**P&Z STAFF REPORT**

Case: **V19-0022 – 0 Glenridge Drive**  
Staff Contact: Madalyn Smith (msmith@sandyspringsga.gov)  
Report Date: December 3, 2019

Requests for the following Variances for the purpose of developing a hotel at 0 Glenridge Drive:

**SITE PLAN** (received November 6, 2019) (full size Site Plan in Package)

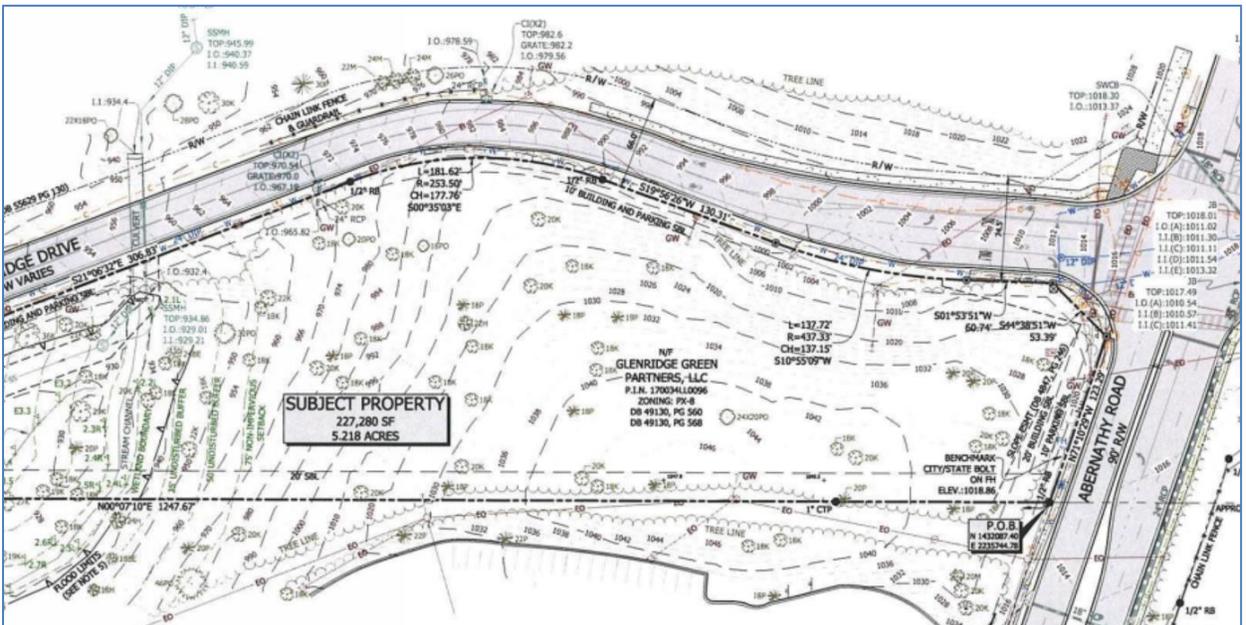
There are extraordinary and exceptional conditions due to the shape and topography of the site. While the lot is fairly large at 5.2 acres, it is only around 200 feet wide. Much of it is unbuildable due to the presence of state waters, floodplain, and wetlands. The portion that is buildable, is a large, steep hill. The narrowness of the property and the topography limit the options for placement of the loading dock. Adherence to this section of the Development Code would require the loading dock to be placed to the rear of the building, which would not eliminate a Variance request because accessing the rear would require the construction of retaining walls ranging from 10-20 feet in height. The retaining walls would require a Variance from either the height limitation of 8 feet, or if the wall is tiered it would require a Stream Buffer Variance. As noted by the City architect, it would also put the loading dock activities adjacent to residential uses. The applicant proposes to locate the loading dock in the most logical place on the site. Therefore, staff recognizes a hardship.

Staff believes this request is the minimum relief necessary as it does not believe there to be a more viable, or better location for the necessary loading dock on the site.

1. The location of the loading dock be substantially similar to that shown on the “*Mayson House Variance Issuance*” plans received October 28, 2019 and subsequent amendments received November 6, 2019.

PROJECT	
DATE	07/26/2019
DESIGNED BY	TAD
REVIEWED BY	BLH
DATE	07/26/2019
PROJECT NO.	019754013
TITLE	<b>GRADING &amp; DRAINAGE PLAN</b>
SHEET NUMBER	<b>C3.00</b>

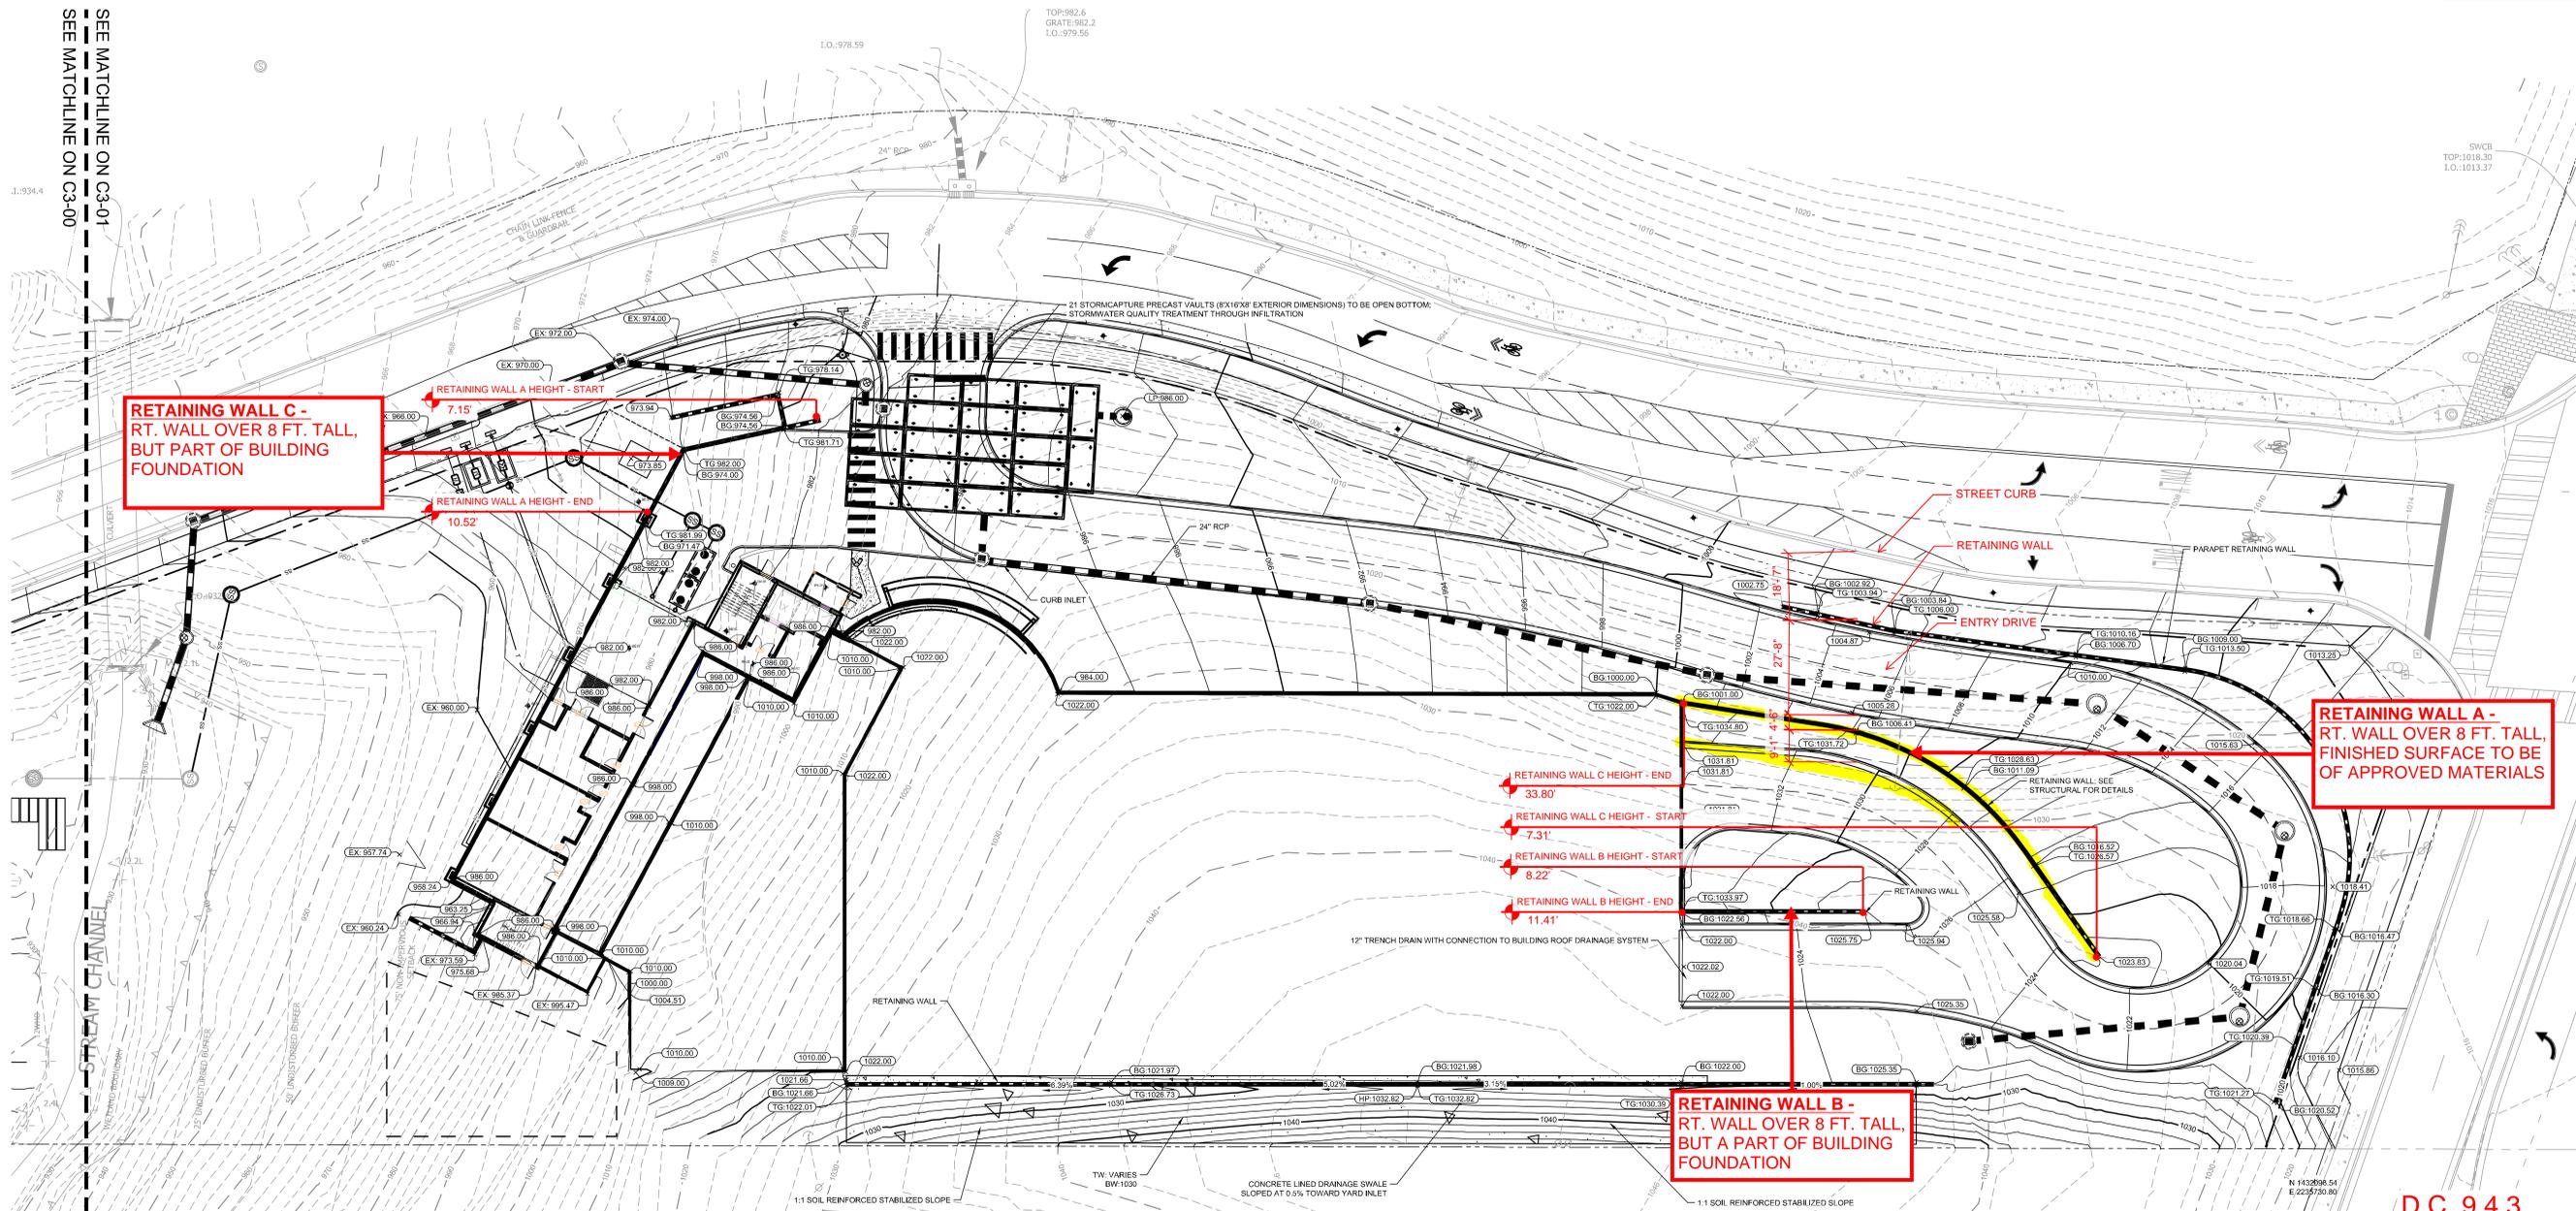
As stated above, there are extraordinary and exceptional conditions due to the shape and topography of the site. The topography of the site is extreme, and the lot shape is narrow. The Development Code requires retaining walls over eight (8) feet in height to be tiered, with each tier separated horizontally by four (4) feet. The proposed wall is 33 feet tall. The narrowness of the property would severely limit the development of the site if the wall had to be tiered for every 8 feet in height, thus creating a hardship and necessitating the Variance request.

The retaining wall is 33 feet tall out of necessity. Without the retaining wall, access to the site is not possible. For this reason, Staff finds the request to be the minimum relief necessary.

Given the amount of rise on the site and its narrowness, the heights of the retaining walls seem inevitable, if our primary goal is to have developments work with their sites' natural topography. The wall height provision is a generally valid one from both an aesthetic and environmental points of view. However, in this case, just as with many mountain roads, the taller retaining walls, properly treated, seem both inevitable and natural.

Concerning the retaining wall height, the retaining walls seem necessary based on the topography of the site; however, the applicant should show a diverse landscape plan to be installed to help block the sight of the walls as much as possible.

1. The height of the retaining wall be substantially similar to that shown on the “*Mayson House Variance Issuance*” plans received October 28, 2019 and subsequent amendments received November 6, 2019.

**NOTE TO REVIEWER:**

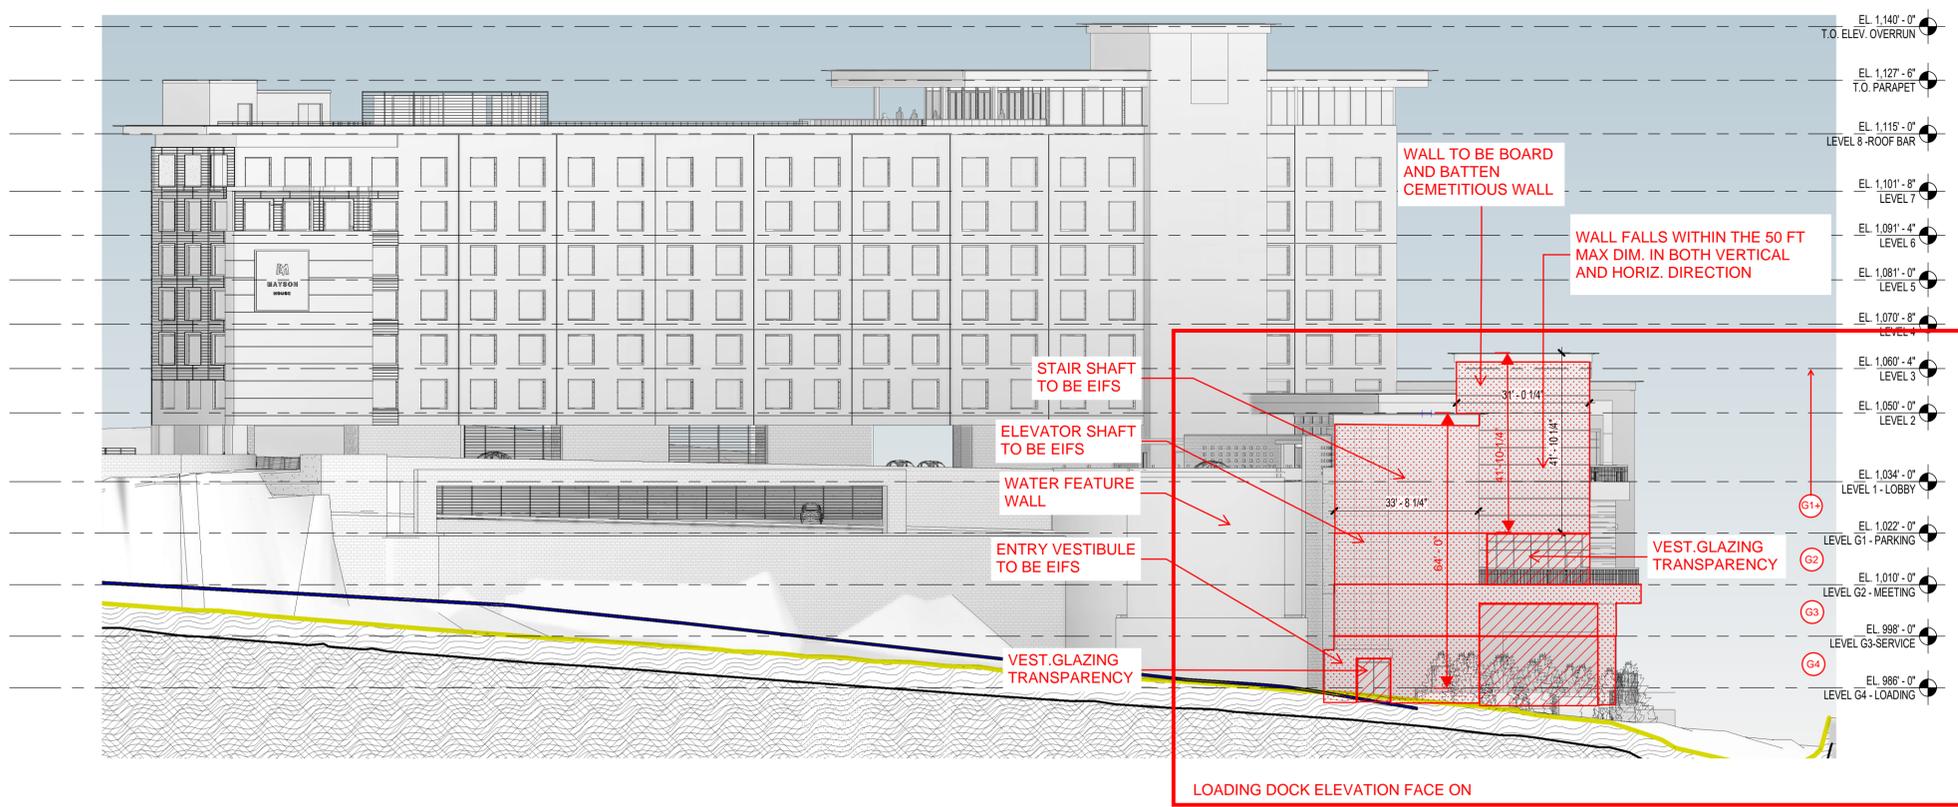
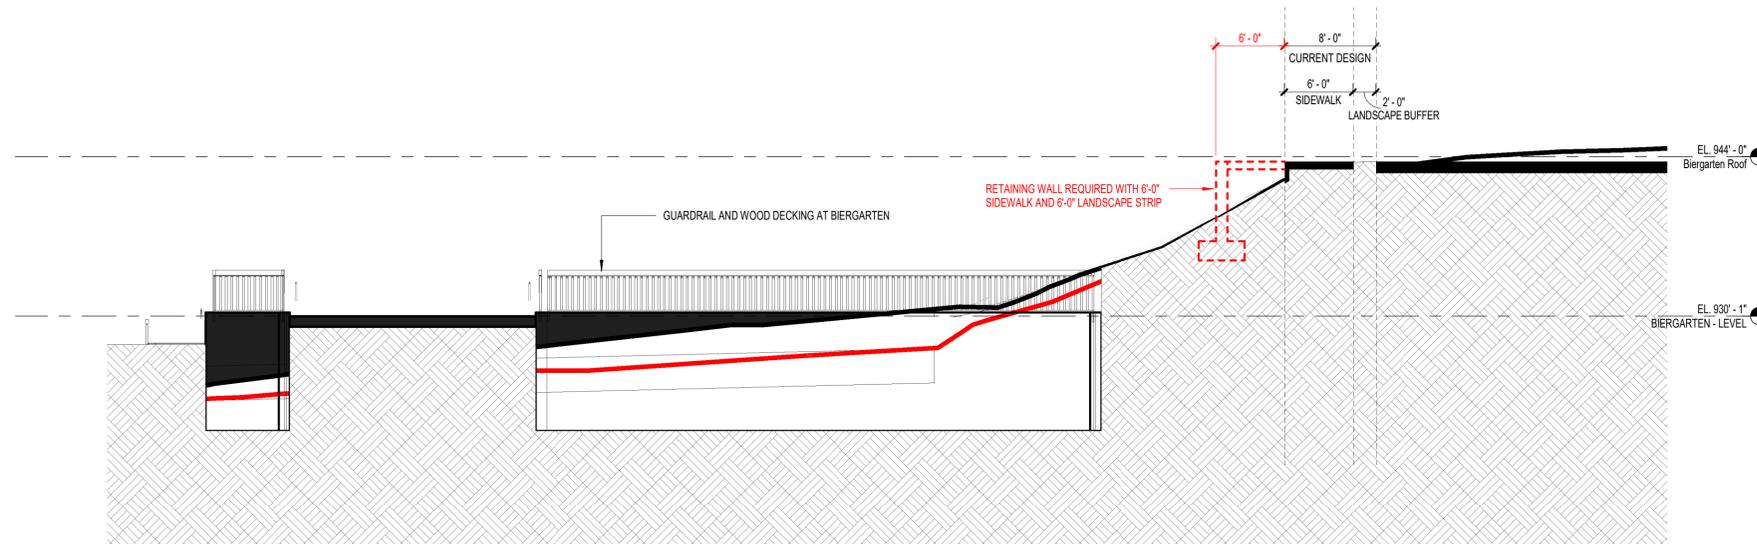
The applicant wishes to have the transparency requirements reduced for a northeastern portion of the hotel, facing Glenridge Drive. This portion of the building is proposed to be approximately four (4) stories and 63' feet in height, and would primarily be the screening an elevator and stairway, near the loading dock and other service area apparatus. While inconvenient to the applicant, there is not a compelling hardship preventing the applicant from providing the proper amount of transparency. In the absence of a hardship, Staff cannot recommend approval of this request.

The applicant requests an exception to the transparency requirements only where there are the proposed service areas. As described by the City architect, glazing the stairwells and elevator shafts would be something minor that can done to meet the requirements of the Code. Staff does not see a hardship and thus does not believe there would be a minimum relief available.

On levels 1-G4 the blank wall facing Glenridge encloses stair and elevator shafts, the exterior wall of both the stair and elevator shaft could be glazed. Each would add around 100 sf of glazing per level or about 30%. The stair appears to end at level G1, not continuing to level 1. At that level the space is part of a kitchen, which may not be appropriate to be glazed however level 1 already meets the code's requirement. The Transparency provisions in our code stem from the goal of activating pedestrian-oriented streets by connecting pedestrians visually to the activities within street-fronting buildings and having those buildings to appear accessible and lively. Glazing the stair, the elevator or both should have an animating effect on that elevation.

**Denial** of Variance V19-0022, Request #1, from Sec. 5.6.4.

1. The deficiency in transparency be substantially similar to that shown on the “*Mayson House Variance Issuance*” plans received October 28, 2019 and subsequent amendments received November 6, 2019.
